BURLINGTON DEVELOPMENT REVIEW BOARD

1. 16-1258SP; 49 Church St (D, Ward 3C) Burlington Mall Associates, LLC

Sketch plan review of mixed use redevelopment (retail, office, residential, and parking garage) of the mall property (Project Managers, Scott Gustin & Mary O'Neil)

TO: Development Review Board
FROM: Scott Gustin & Mary O'Neil, Principal Planners
DATE: June 28, 2016
RE: 16-1258SP; 49 Church Street

ST. PAULS STREET
ELEVATION **A-203**
9 MAY 2016

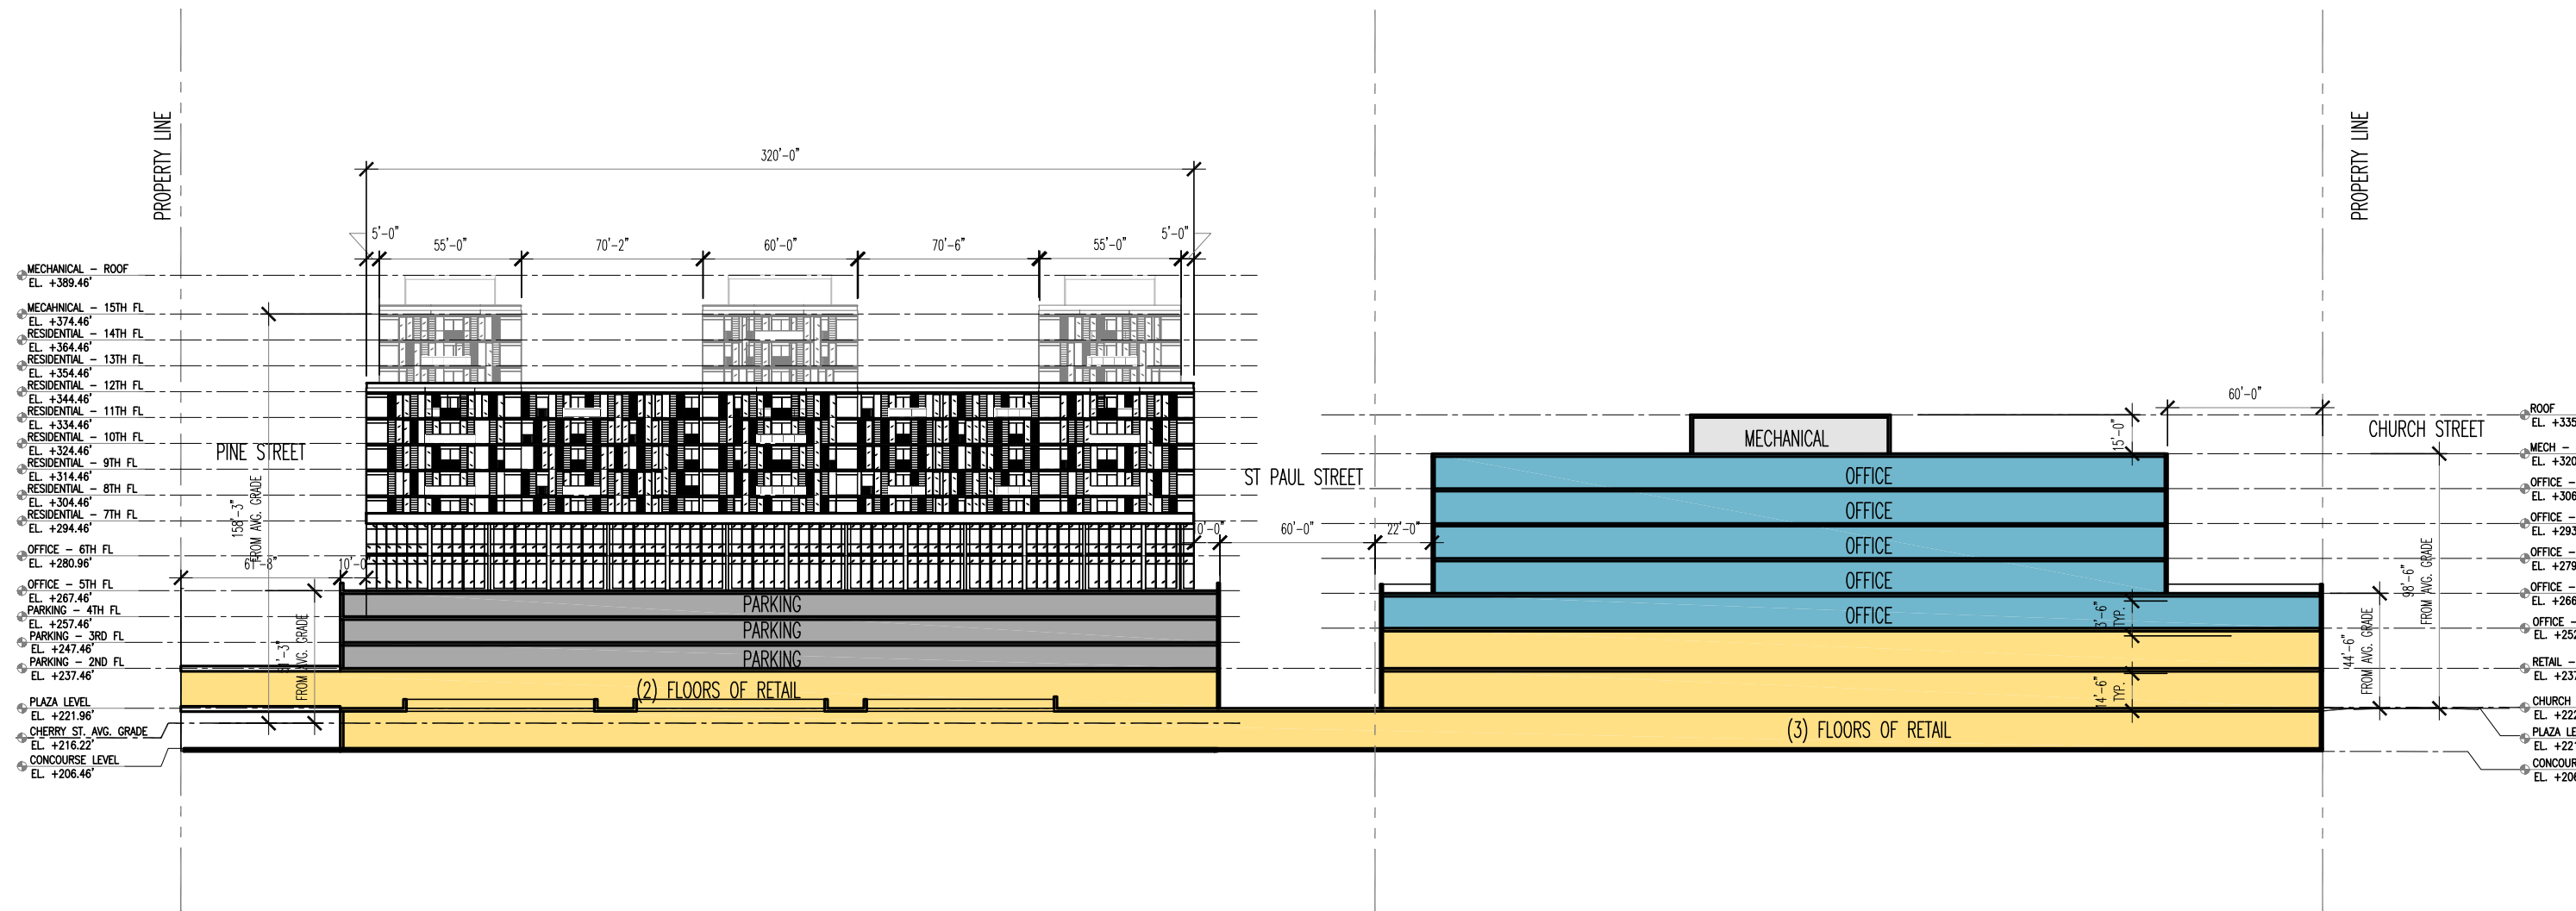
15. *As shown on the St. Paul Street Elevation on sheet A-203, the St. Paul Street extension rises at a 6.9% slope from Bank Street to the middle of the block, and then slopes down to meet Cherry Street. This is due to the presence of the Burlington Arcade below, at the Concourse Level. The 6.9% slope is a dramatic difference in rise compared to the existing Bank and St. Paul Streets to which it connects with, and the 6.9% slope hampers the ability of the new St. Paul Street extension to act and feel like it is naturally integrated with the downtown street*

grid. The Burlington Arcade at the Concourse Level should be modified or depressed to allow for a street slope of 5% maximum, 4% preferred.
